Environment Southland
Private Bag 90116,
Invercargill, 9810

OVERSEERFM AUDIT – RESPONSE TO IRRICON REPORT QUESTIONS

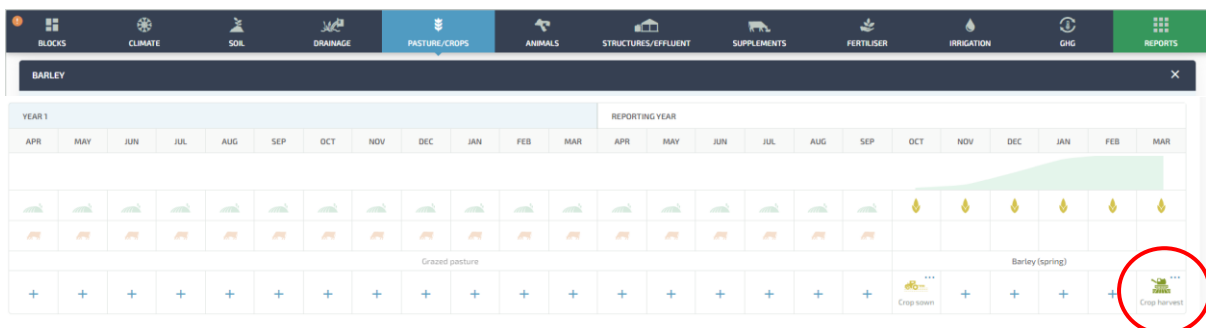
2. Please explain why there is no harvest date for the barley crop in the Prop wo model

Response: The harvest date is in the Prop wo model (see below under pasture crops -> crop blocks -> barley -> edit crops -> crops on barley). I am unsure why this wasn't seen in the audit?
